DESIGN REVIEW COMMITTEE MEMORANDUM

SUBJECT: File No.: **ADR21-0004**; Chalk Hill Winery Existing Signs
Applicant: Shaun Harder
Address: 10300 Chalk Hill Rd., Healdsburg
APN: 079-120-016

Request

Project plan and materials exhibit

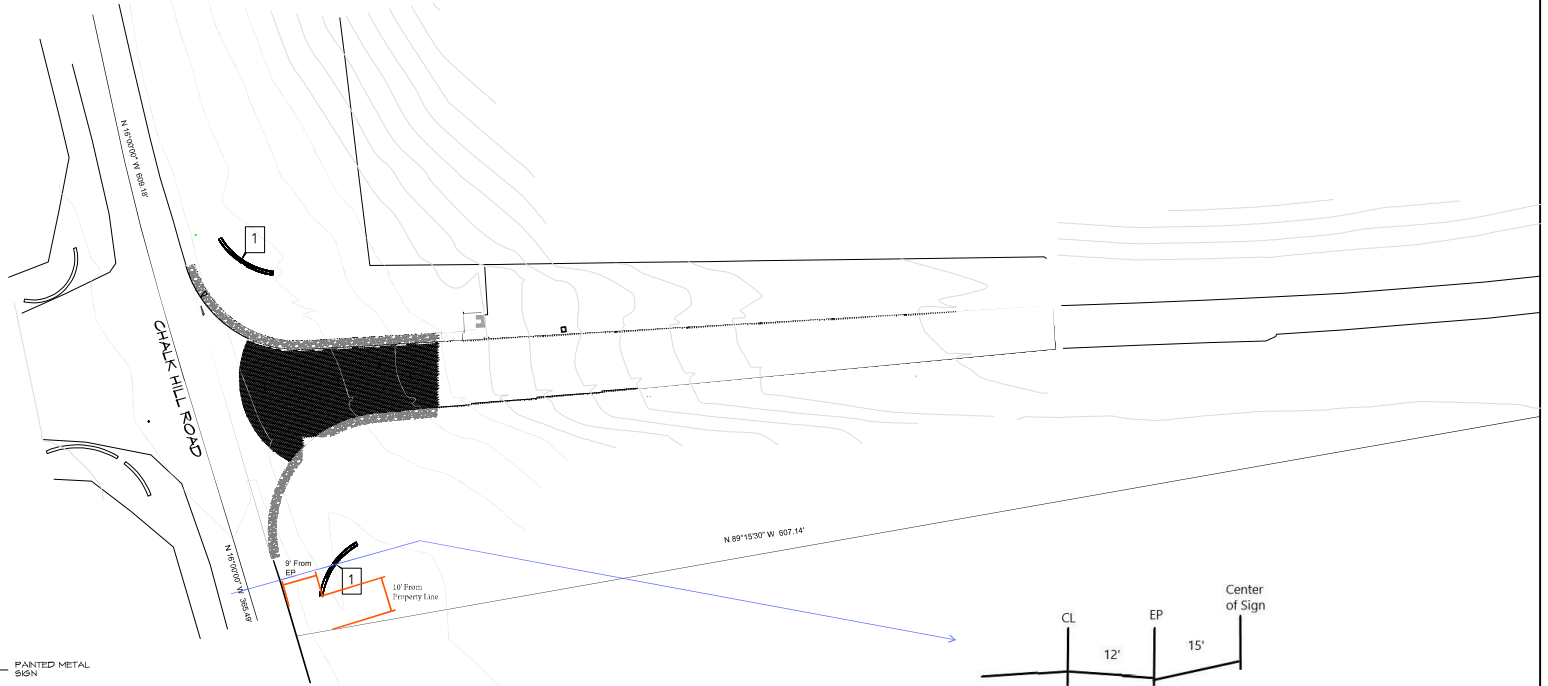
- Design. The signs are located on both sides of the winery's driveway entrance, off Chalk Hill Road. The signs are made of concrete which shows in its natural grey color, have off-white painted frames, minimalistic hill logo also painted off-white, and a written "CHALK HILL" is painted dark. Each sign sits on top and the center of a stonewall showing its natural beige and warm colors. The signs sit in landscaped areas, which do not require irrigation as they are composed by small rocks which are multicolored and where the beige color domains, and some other drought-tolerant plants surround. A stone-composed storm-water management feature, which is similar in appearance of the signs stonewall, separates the signs landscaping areas from the roads which gray color is similar to the grey on the signs' faces. The signs are not illuminated, they each have a surface area of approximately 38 square feet and reach a 4'-6" height. Since the signs are less than 6' tall, there are not subject to front yard or corridor preservation setbacks; and are adequate at the current

location of 9' from the road. The signs are compatible with the immediate vicinity, per their design specifications and use. Staff does not find any issues with the design of the signs.

- The signs do not represent any danger to the public, environment or animals in any way.
- The only requests for exceptions, is that to exceed the limitations shown in the Signs Regulations "Article 84" of the Zoning Code for limitation of 1 sign and 32 square feet; by proposing 2 signs and an approximate total of 76 square feet. Per said Article Sec. 26-84.030(d), these exceptions may be granted only upon approval of the DRC.
- There are no compatibility concerns with this project, as it proposes signs for a winery on-site. Signs for a neighboring winery are located immediately across Chalk Hill Road from this project's signs. The immediate vicinity includes other wineries, which also connect via Chalk Hill Road.

Approve the project as existent.
